Block 21 Design Response

05.06.2022

In the planning process Block 21 was reviewed by the City's design consultant, Cannon Design Group. The findings and recommendations of the design consultant were provided to the project team in a letter dated November 10, 2021.

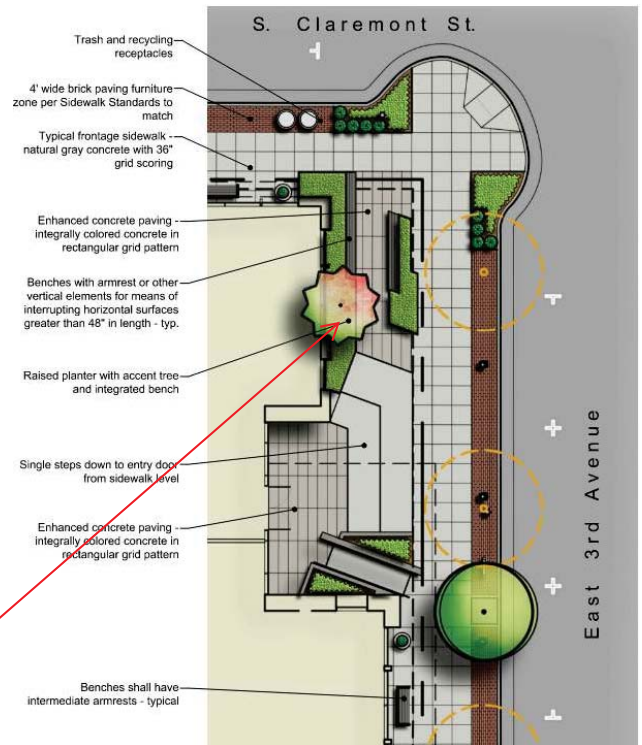
2. Add a projecting cornice or roof canopy at the second level to emphasize the two-story massing along street frontages to better relate to the adjacent new projects and the pedestrian scale of the sidewalks. At the planning commission's discretion, the third floor could also be setback to reduce its impact on the overall building massing and the human scale of adjacent pedestrians.

Response: We have made significant massing adjustments to the proportion of the cornice at the second level to create a better scale for the building.

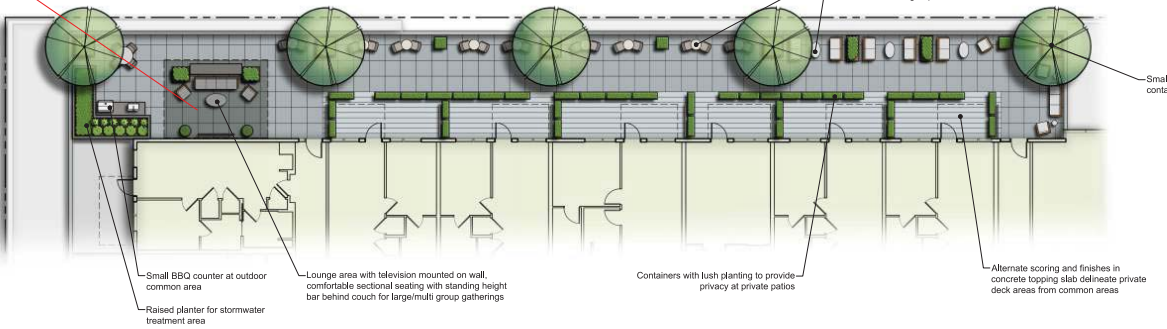
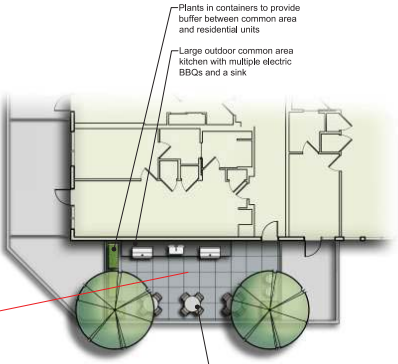
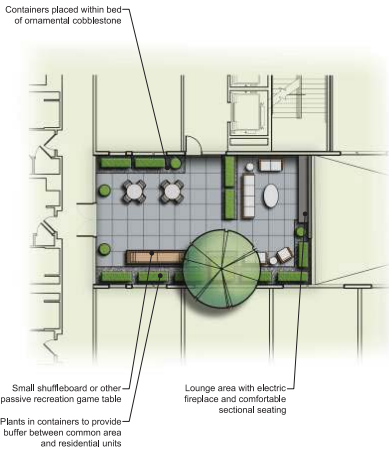
10. Resolve the privacy and landscaping of the spaces adjacent to the open atrium on the fourth floor.

Response: The privacy and screening is accomplished with a combination of a fireplace wall and landscape planters.

ADDITIONAL LANDSCAPING AND AMENITIES FOR ACTIVE PEDESTRIAN FRIENDLY CORNER PLAZA

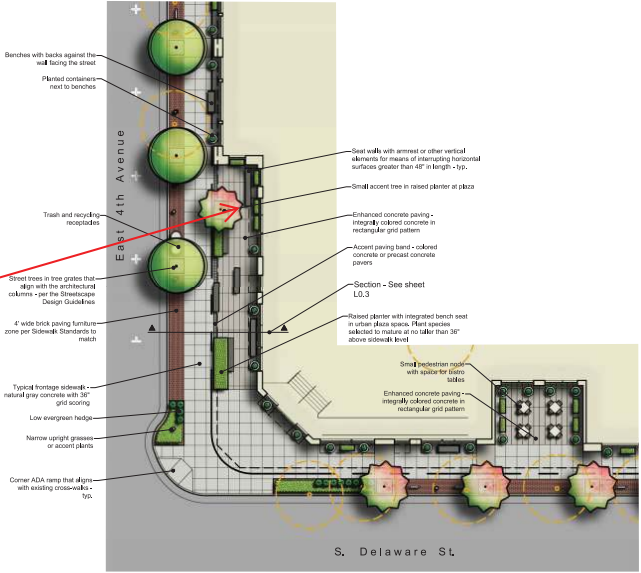
12. Consider adding more landscaping at the small plaza at the corner of East Fourth Avenue and South Delaware Street.

Response: The planters have been enlarged to provide additional planting. The design allows for the landscape areas in the planters while also providing the pedestrian circulation and seating for an active streetscape.
